TOWN OF HOTCHKISS  
PUBLIC WORKS FACILITIES

ADDENDUM NO. 1

**PLUMBING - SHOP FLOOR PLAN**  
SCALE: 1/8"=1'-0"

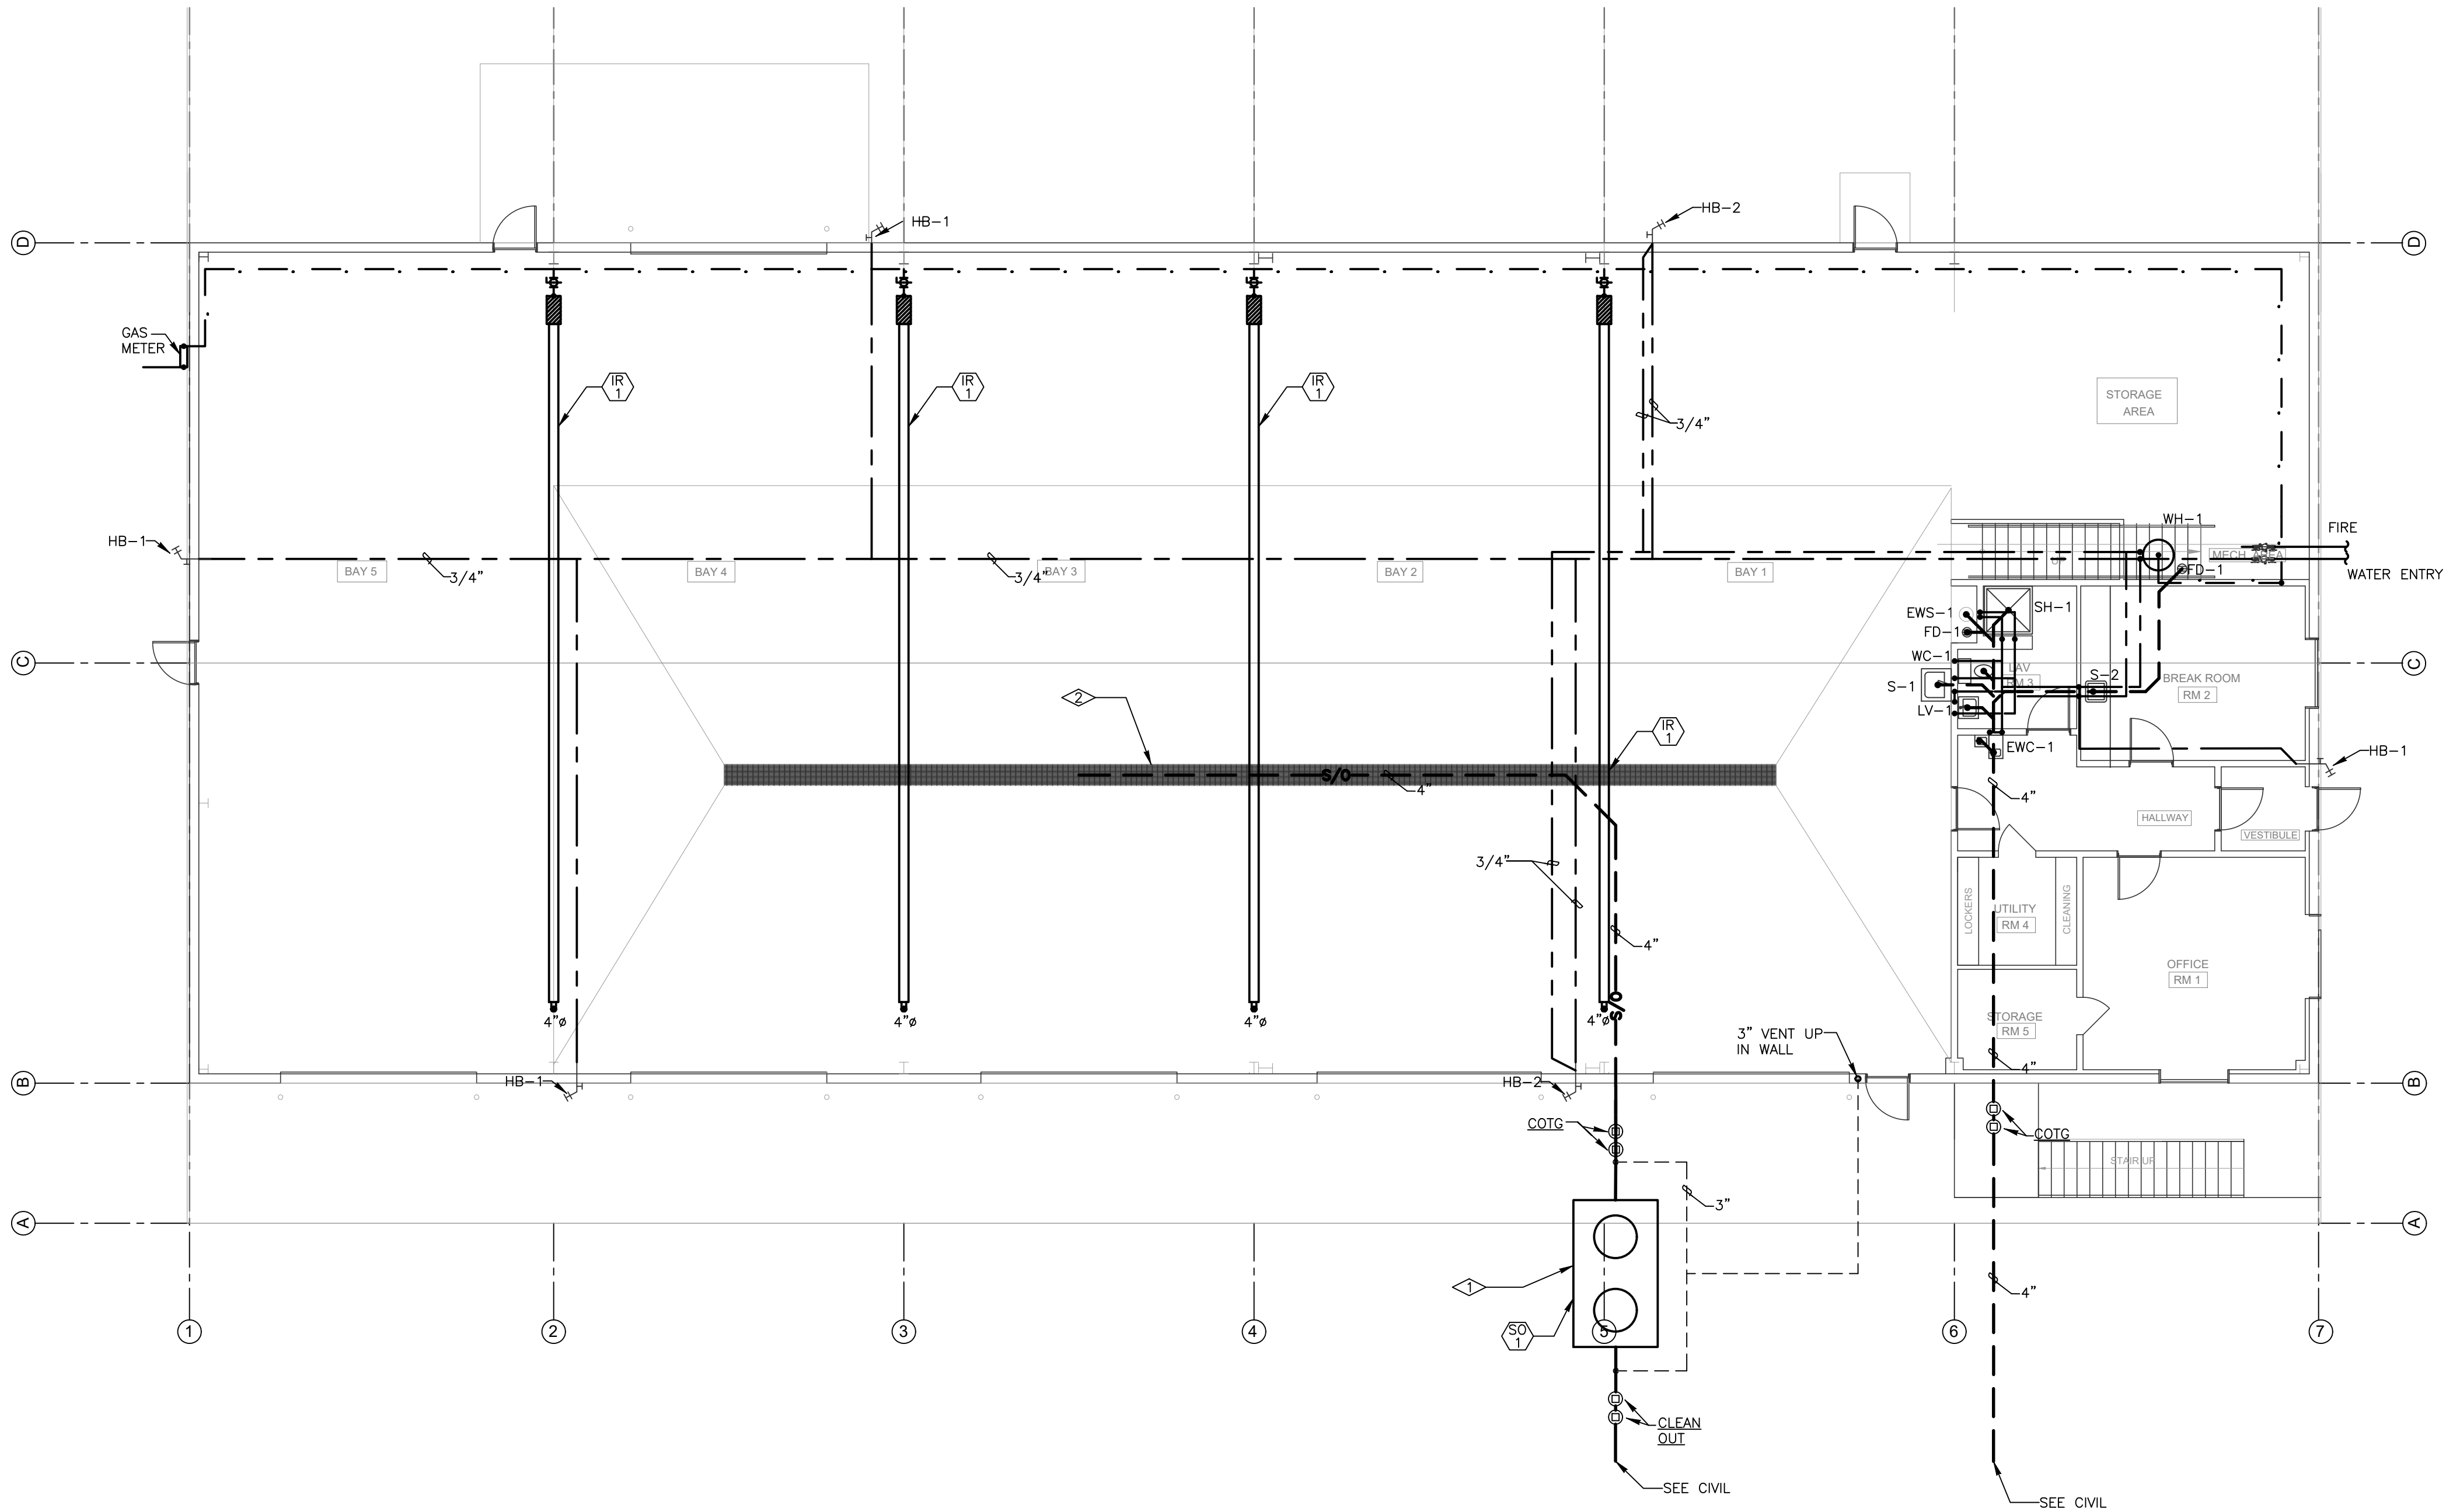
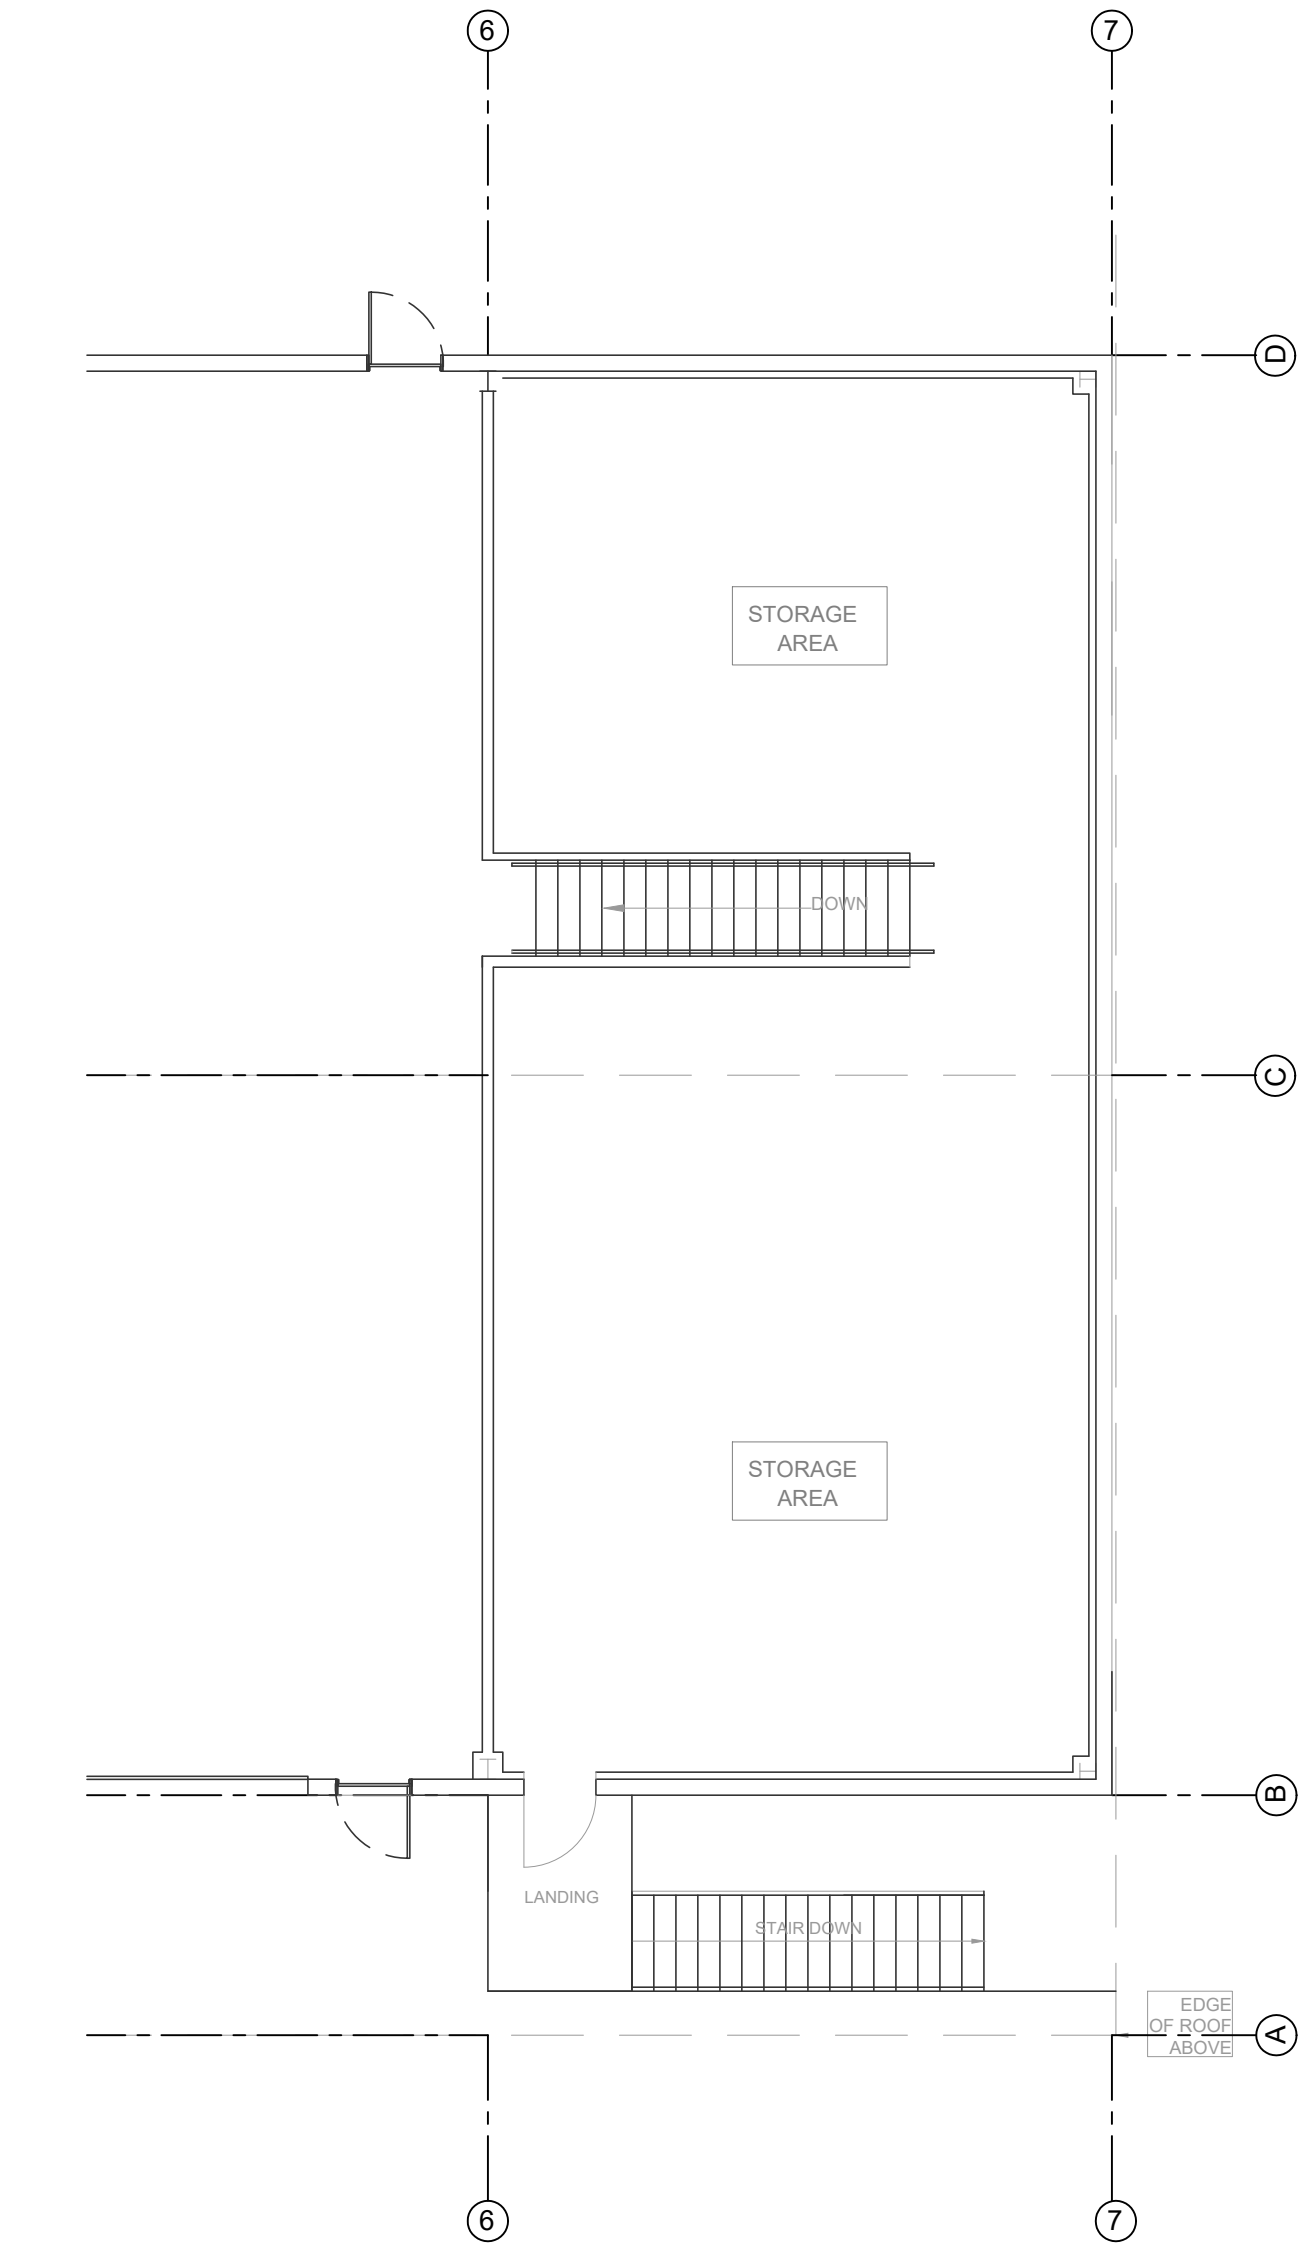
CLARIFY Sheets C-2 and P1-2. Clarify that the domestic water service line is 1.5" and the fire connection on the building is a 4" line. Each should be tapped from the 6" main that runs north south from just east of the hydrant as shown on C-2. Domestic water meter and reduced pressure backflow preventor are to be located under the stairs before the hot water heater.
